Highpoint Drive Subdivision

CITY of MEDINA

Case No: P16-06

Subject: South Court Village Development – Preliminary Subdivision Plat

Site Plan

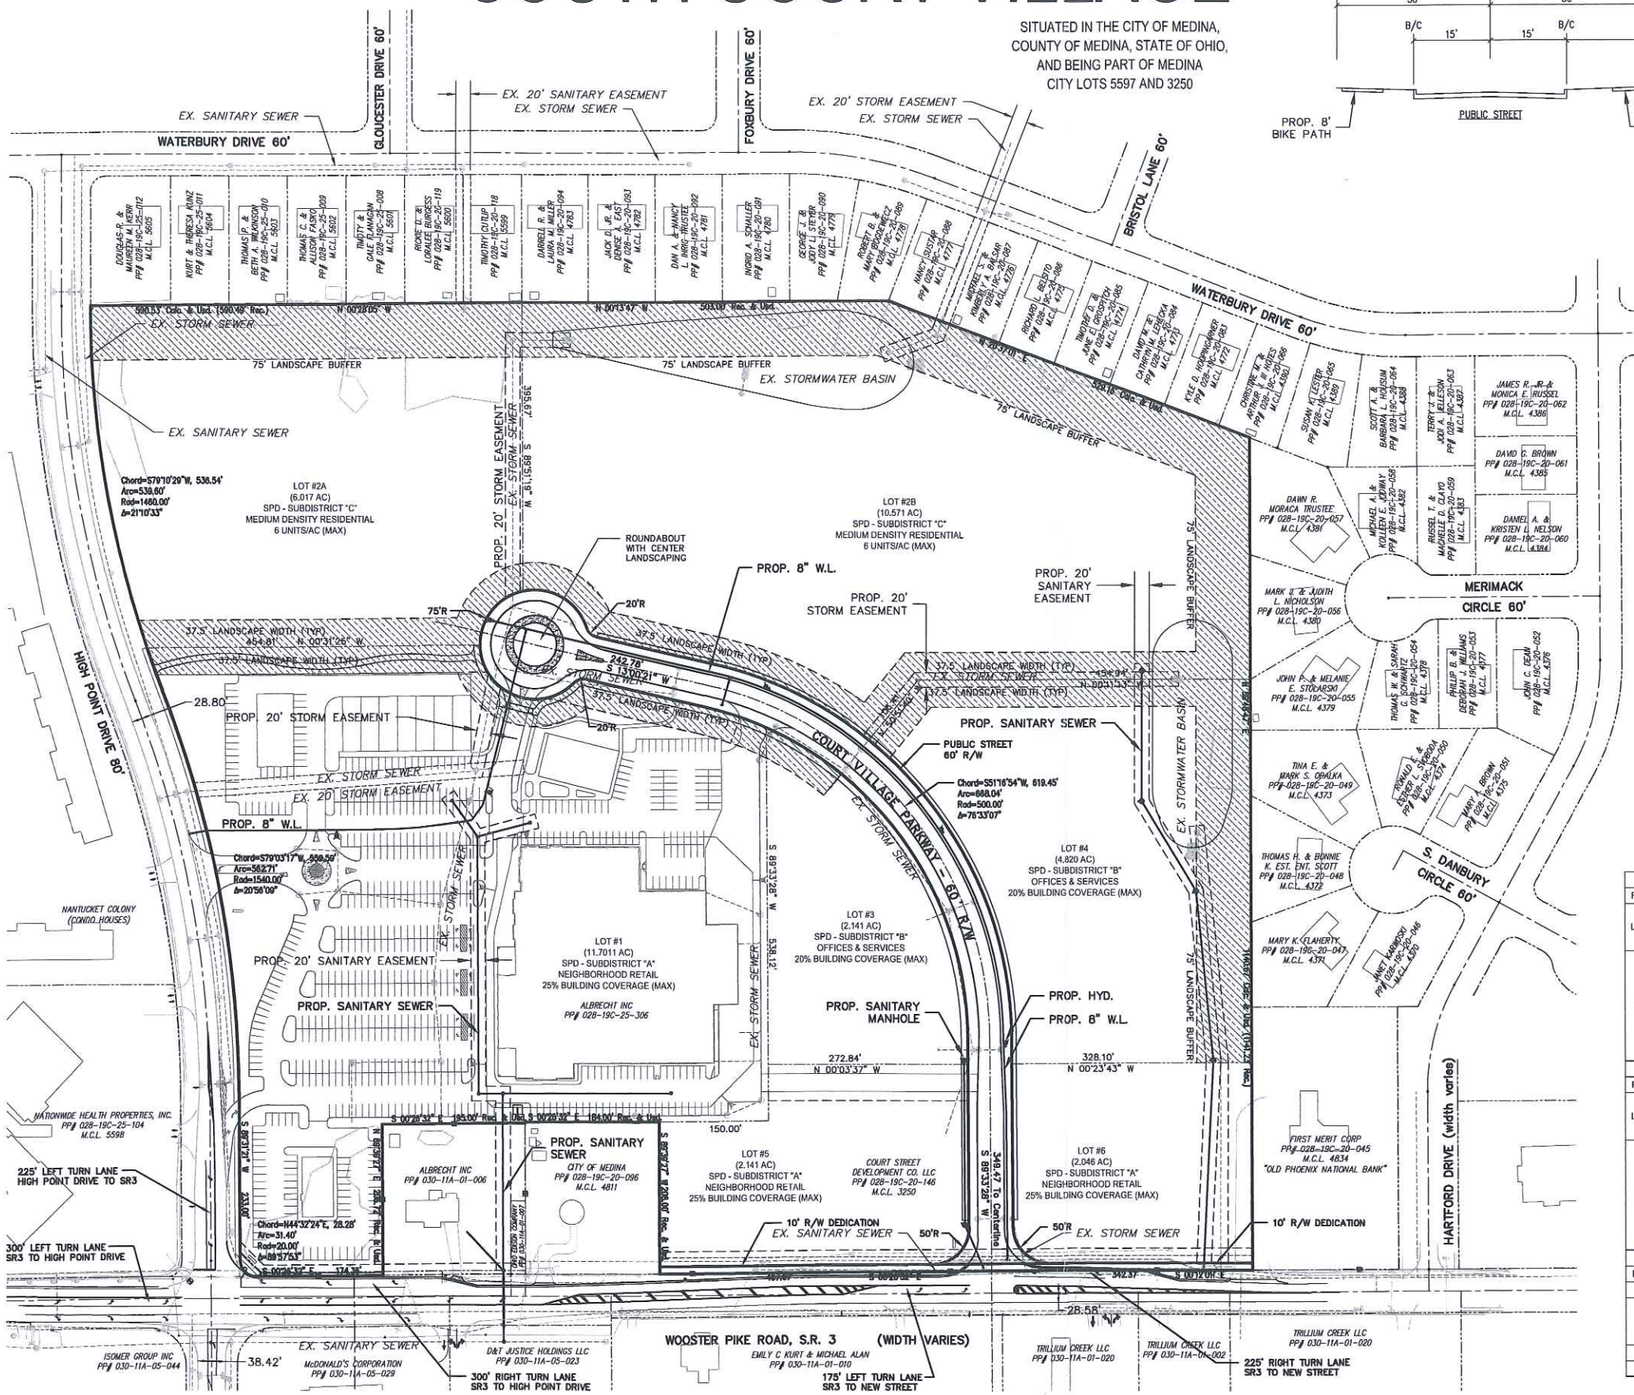
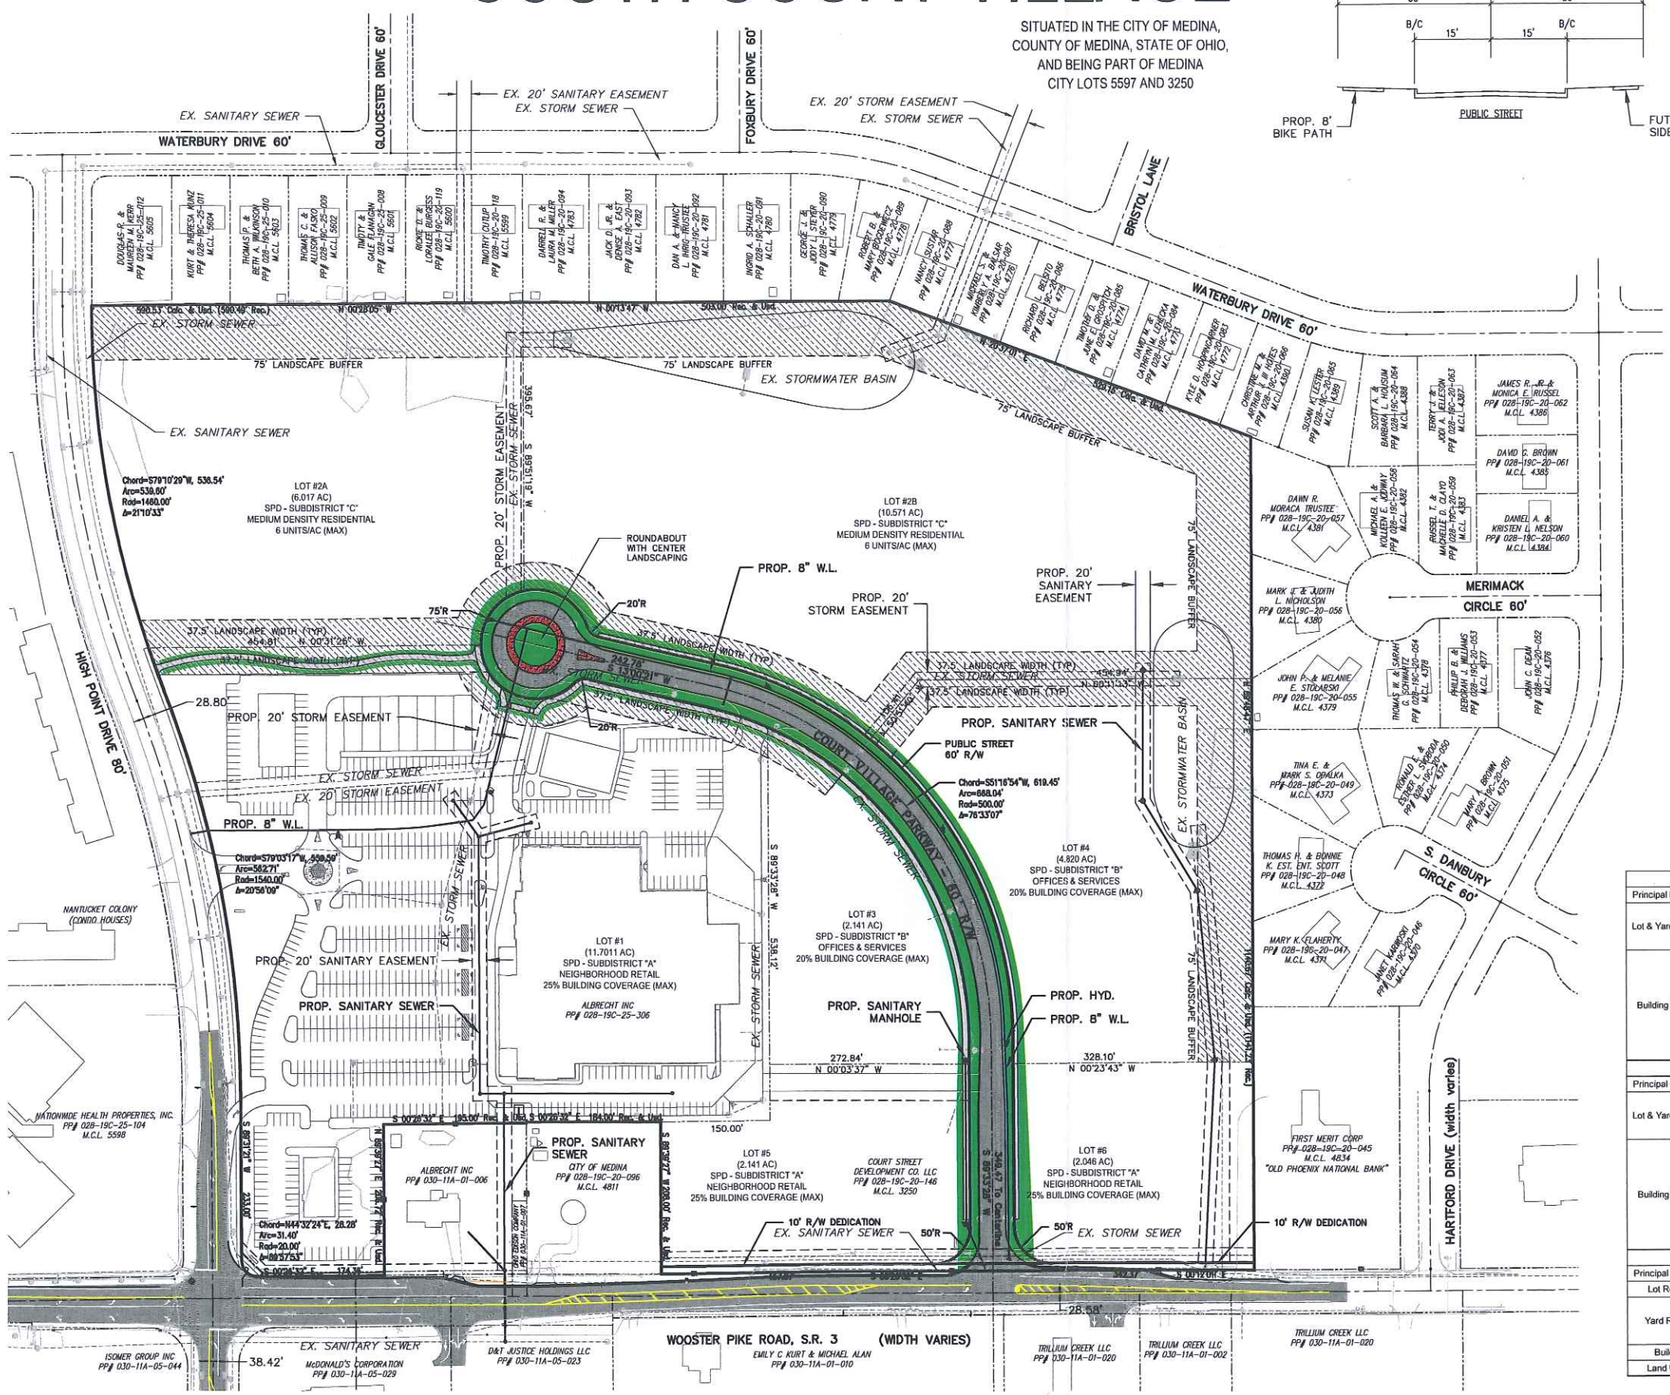
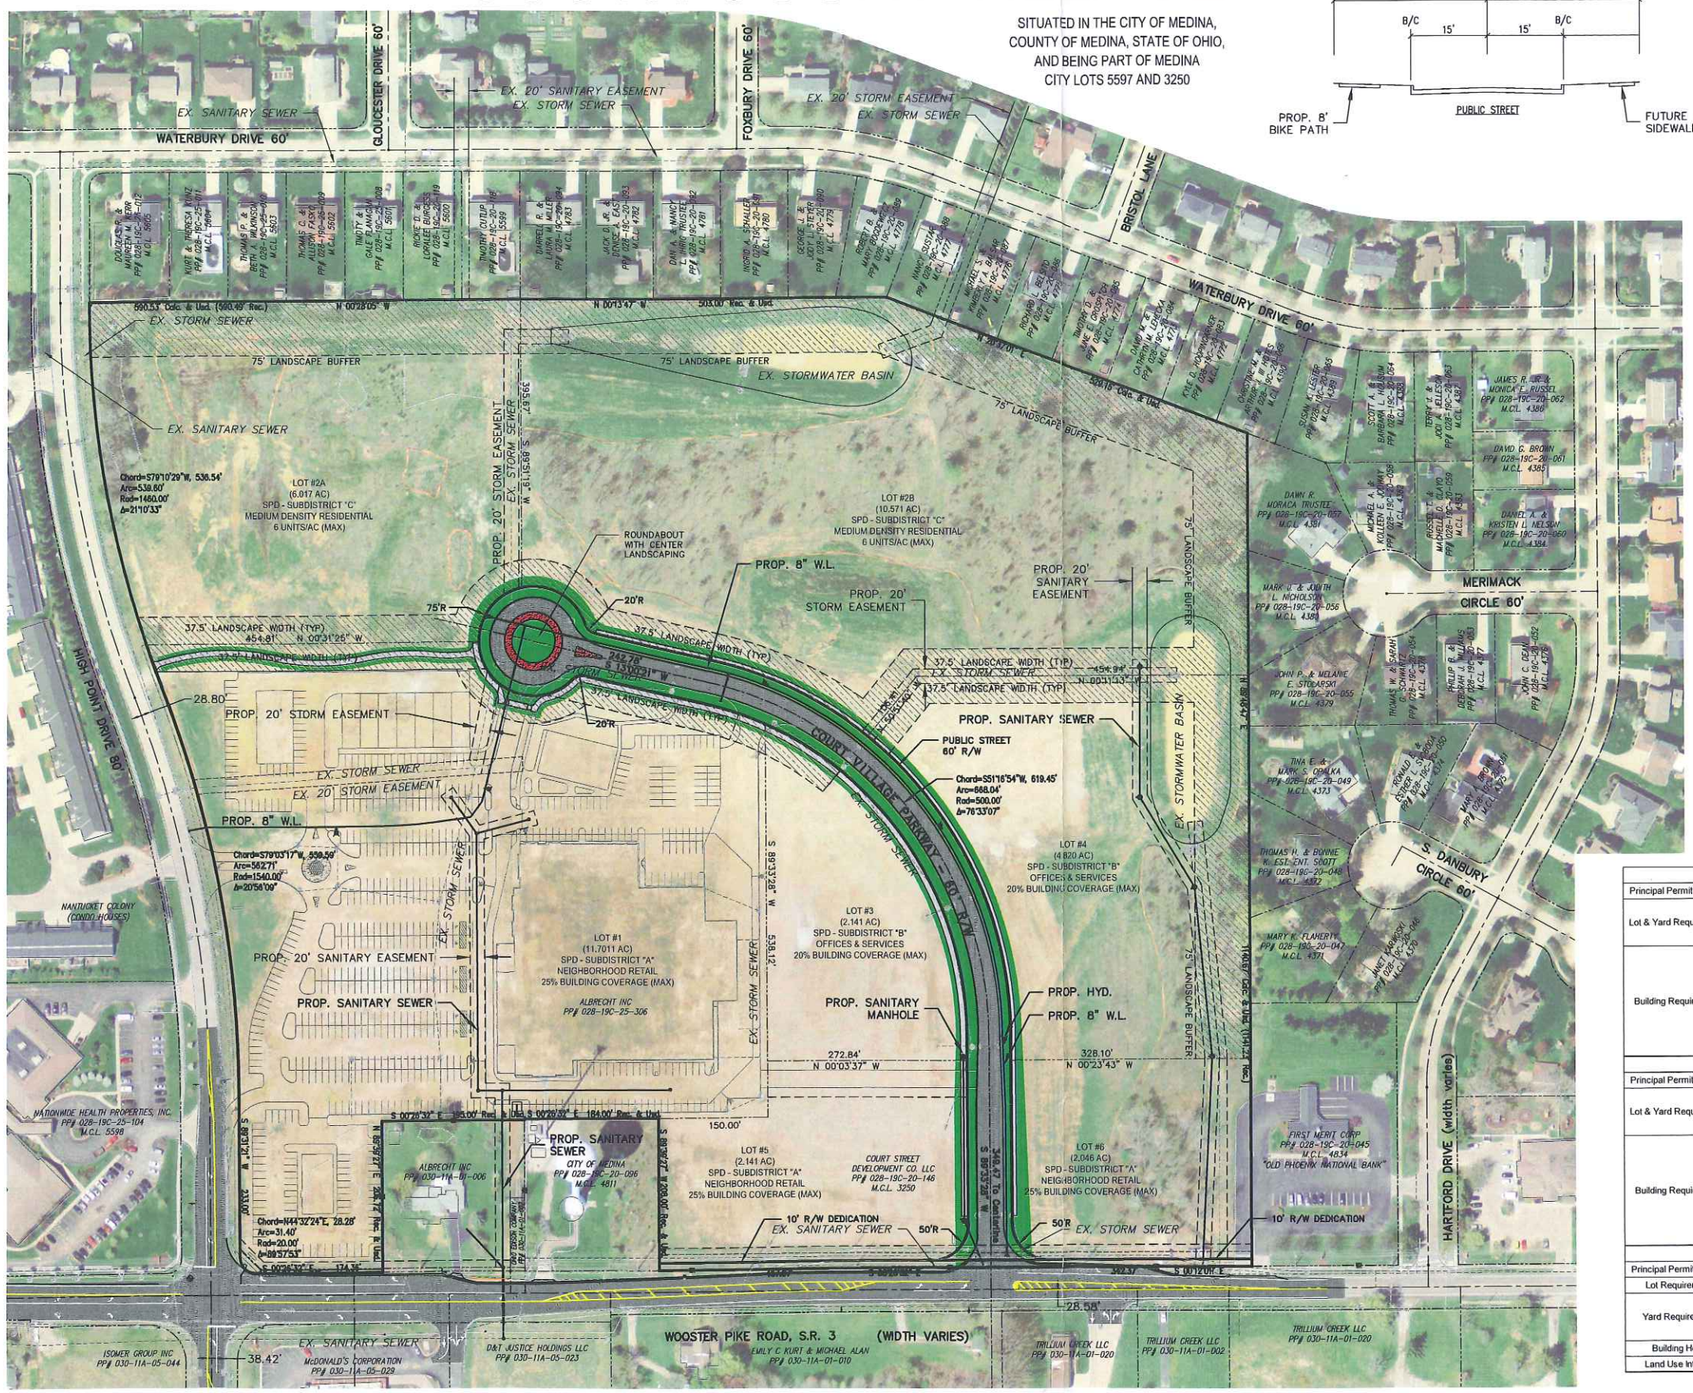
Access
Establish access easements to allow connection from Lot #1 to Lots #3 and #5 to the proposed local street. Additionally, an easement must establish access between lots #4 and #6 also the proposed public local street. These requirements are outlined in Section C.5(4) of the underlying SPD-1 established by Ordinance 207-06 in order to minimize vehicle access points to all public streets.

The proposed public street extending into the development from S. Court has a proposed name (Court Village Parkway) that is too similar to S. Court St from which it extends. Rename the new street to be sufficiently distinct from S. Court Street or any other similar public street within the Medina postal delivery area.

The long cul-de-sac for the proposed local street exceeds the maximum 600 feet length as required by Section 1171.02(b)(4) of the Planning and Zoning Code.

The proposed cul-de-sac is approximately 1,200 feet long, which is significantly more than permitted. Additionally, the cul-de-sac turnaround at the southerly end has a landscaped roundabout island that results in the outside paving radius of only 30 feet as opposed to the minimum 50 feet. This intent of this minimum radius to allow for safe vehicle passage and provision of public services, such as snowplowing, trash removal and emergency vehicle access.

1) Hydrant will need to be spaced every 300 feet on the road way.
2) Court Village Parkway needs to be a thru street to High Point Dr.
3) The Island needs to be either removed or the road area needs to be large enough to allow the move ability of our largest fire truck.
4) The fire department has major concerns of access to all areas as they are developed. If a cul-de-sac is approved there will be only one way into a lot of the areas so as they are developed we will be requesting additional access into these areas, especially for the residential areas. Also all drive ways will need to be large enough to allow turning into the lots with our vehicles. Even though we have commented that fire hydrants will need to be located every 300 feet on the proposed street, there is a very good chance that additional fire hydrants will be requested in each area as they are being developed.

1. Prepare and record a shared access agreement for the shared access easement between lots 1, 3, & 5. Prepare and record a shared access agreement between lots 4 & 6 from the proposed public local street. These requirements are outlined in Section C.5(4) of the underlying SPD-1 established by Ordinance 207-06. Depict record additional shared access or circulation agreements as needed.

50–SCALE
34' FIRE TRUCK MOVEMENT

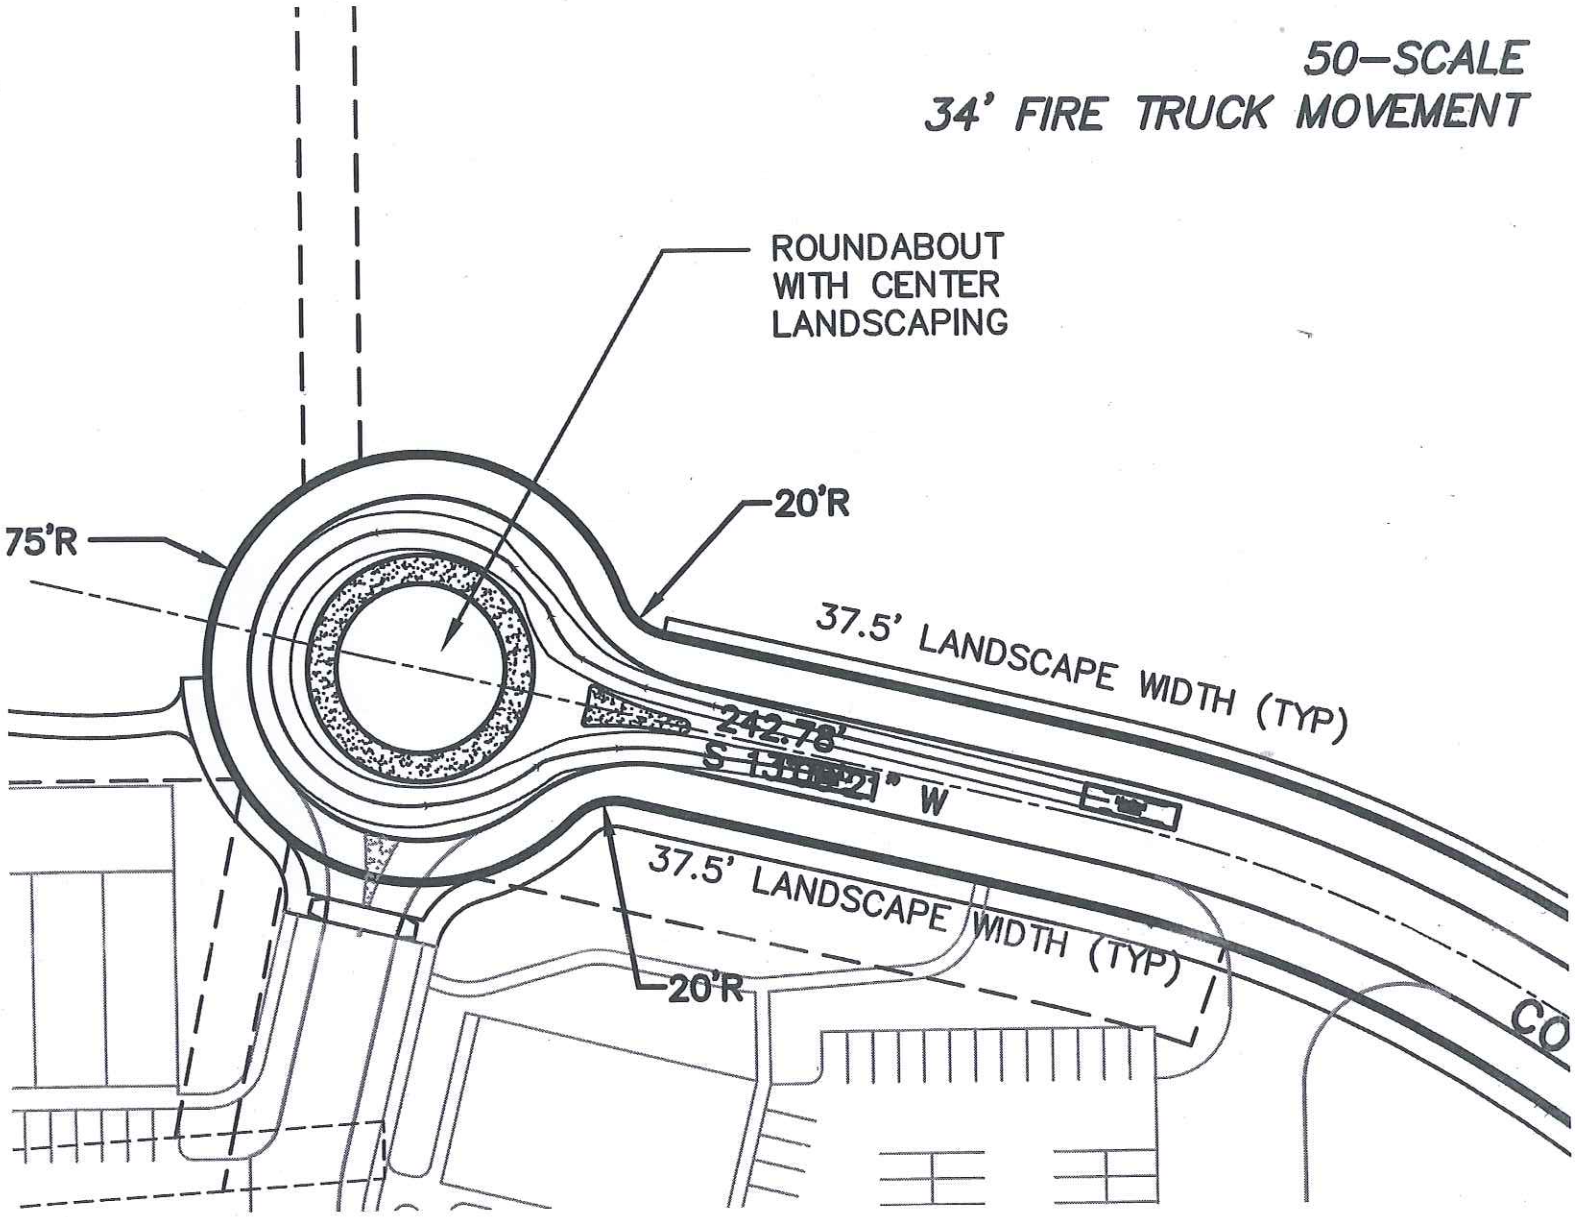
We also wish to respond to comments in regards to the landscaped center island and ability to navigate around the circle. The roundabout was designed per typical roundabout standards and meets all vehicular routing requirements. The roundabout consists of an outer pavement edge radius of 60' and an interior radius of 40' providing a drive aisle of 20' in width. In addition to the interior radius, the roundabout is constructed with a rolled curb on the interior to a stamped concrete surface for an additional 10' of pavement. This will create a pavement width of 30' allowing larger vehicles to traverse the roundabout without issue. Attached demonstrates a 34' ladder truck navigating around the roundabout without any restrictions. We can route additional vehicles at your request and route a specific fire truck of the City of Medina once we have the truck parameters to demonstrate ease of access.

We originally proposed landscaping (and having on-going maintenance responsibility for) the center of the roundabout to mirror the landscaping plans for the retail acreage and create a "sense of place," but during conversations related to turning radius needs and such agreed to change the interior circle to an attractive stamped and colored concrete surface.
